AS PROPOSED

BUILDING DESIGN PARTNERSHIP LTD SHALL HAVE NO RESPONSIBILITY FOR ANY USE OF THIS DOCUMENT OTHER THAN THAT FOR WHICH IT WAS PREPARED AND ISSUED. ALL DIMENSIONS SHOULD BE CHECKED ON SITE. DO NOT SCALE FROM THIS DRAWING. ANY DRAWING ERRORS OR OMISSIONS SHOULD BE BROUGHT TO THE ATTENTION OF BUILDING DESIGN PARTNERSHIP LTD AT THE ADDRESS SHOWN.		EXISTING / PROPOSED FABRIC ■ EXISTING FABRIC □ PROPOSED FABRIC	DRAWINGS TO BE READ IN CONJUNCTION WITH "2020696 Schedule of Changes Final Consent" PROPOSED CHANGE No. XX	18 Brewhouse Yard Chiswick London, ECUV 4LJ United Kingdom T +44 (0)20 7812 8000 F +44 (0)20 7812 8599 www.bdp.com	BDP. 42 BEDFORD SQUARE P2020696 LOWER GROUND FLOOR REFLECTED CEILING PLAN AS PROPOSED (15)AC121_MH	SCALE 1:50 DATE 12.2017 SHEET B
--	--	--	---	--	--	--

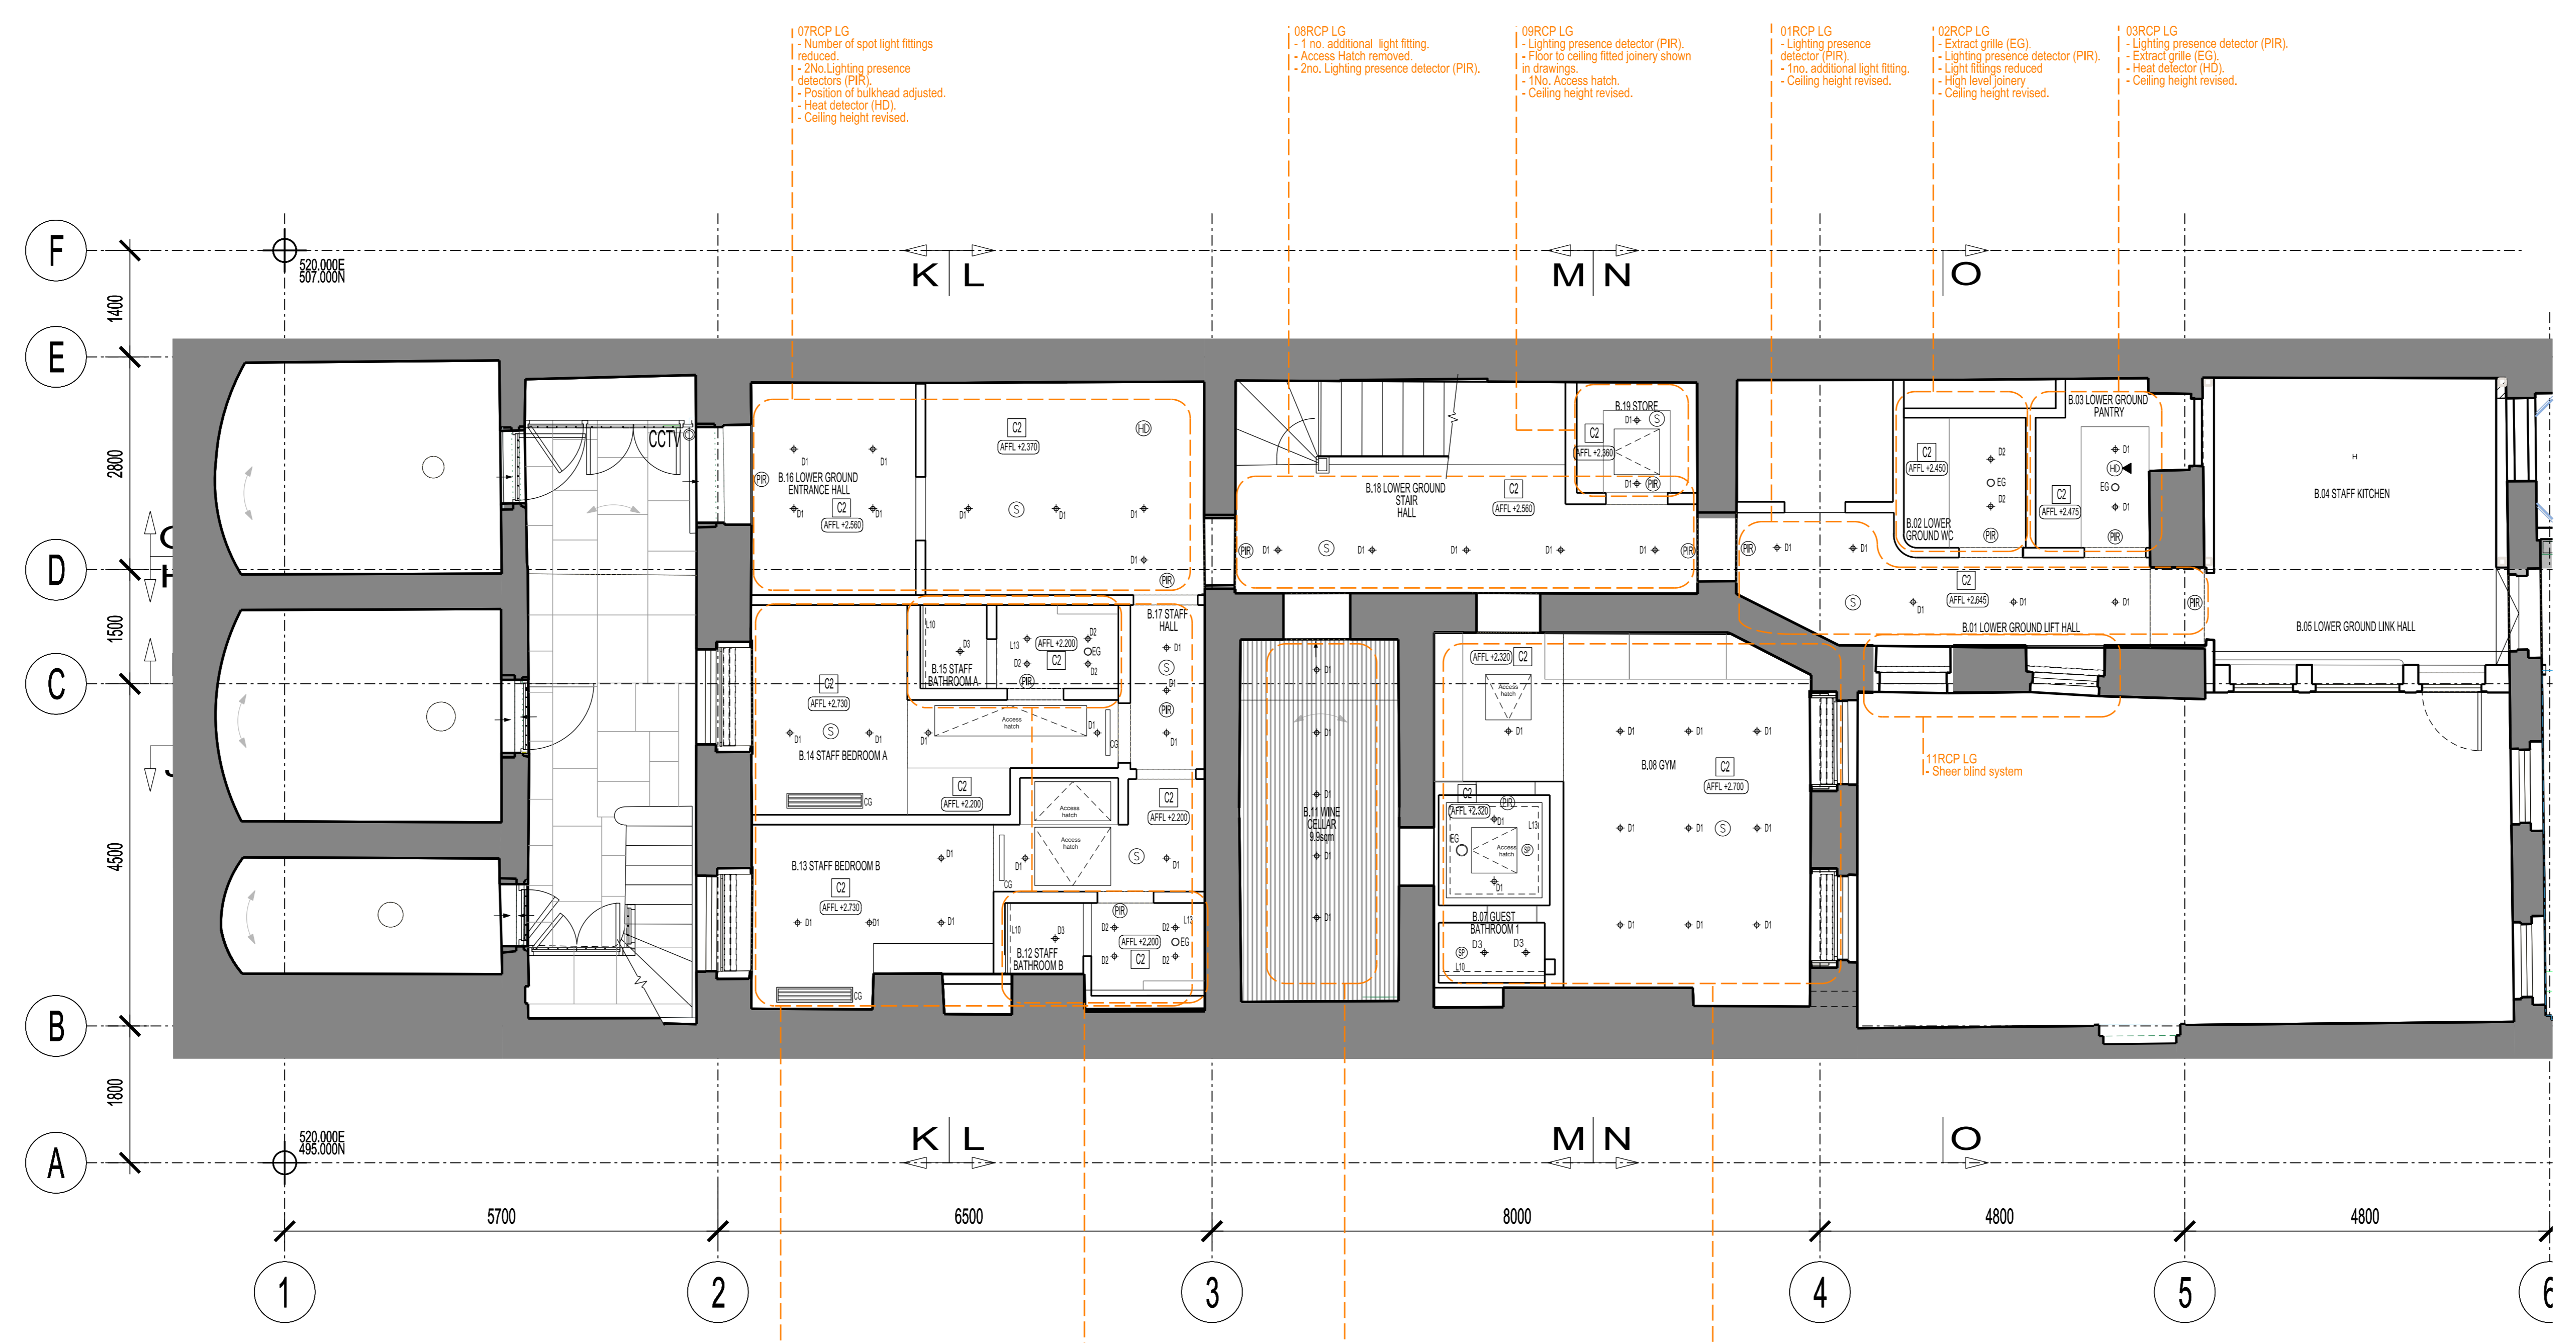
01RCP LG
 - Number of spot light fittings reduced
 - 2no. Lighting presence detector (PIR)
 - Position of bulkhead adjusted
 - Heat detector (HD)
 - Ceiling height revised.

02RCP LG
 - 1 no. additional light fitting
 - Access Hatch removed
 - 2no. Lighting presence detector (PIR)
 - No. Access hatch
 - Ceiling height revised.

03RCP LG
 - Lighting presence detector (PIR)
 - Floor to ceiling fixed joinery shown in drawings
 - No. Access hatch
 - Ceiling height revised.

04RCP LG
 - Lighting presence detector (PIR)
 - 1no. additional light fitting
 - Ceiling height revised.

05RCP LG
 - Extract grille (EG)
 - Lighting presence detector (PIR)
 - Light fittings reduced
 - High level joinery
 - Ceiling height revised.

06RCP LG
 - Lighting presence detector (PIR)
 - Extract grille (EG)
 - Heat detector (HD)
 - Ceiling height revised.

06RCP LG
 - New bulkhead to bedroom B.13
 - Ceiling grille (CG)
 - Lighting presence detector (PIR)
 - Access Hatch relocated, size adjusted and one more added
 - Number of spot light fittings reduced in room B.14
 - 1 no. additional spot light fitting to room B.13
 - Blackout and sheer blind system
 - Floor to ceiling fixed system
 - Ceiling heights revised.

07RCP LG
 - Ceiling and grid grille (EG) to bathroom B15
 - Access Hatch removed to bathroom B15
 - Lighting presence detector (PIR) to bathroom 15
 - Ceiling ceiling detail in shower enclosure with strip light

08RCP LG
 - Lighting included in RCP
 - New bulkhead above door opening.

09RCP LG
 - Layout change following removal of sauna
 - Number of light fittings reduced & revised layout
 - New bulkhead to entrance
 - 2no. Access hatch
 - Floor to ceiling fixed joinery
 - Blackout and sheer blind system
 - Ceiling heights revised
 - Ceiling heights revised
 - Squelch relocated to bathroom
 - New extract grille (EG) to bathroom
 - Lighting presence detector (PIR) to bathroom
 - Ceiling ceiling detail in shower and bathroom with strip light
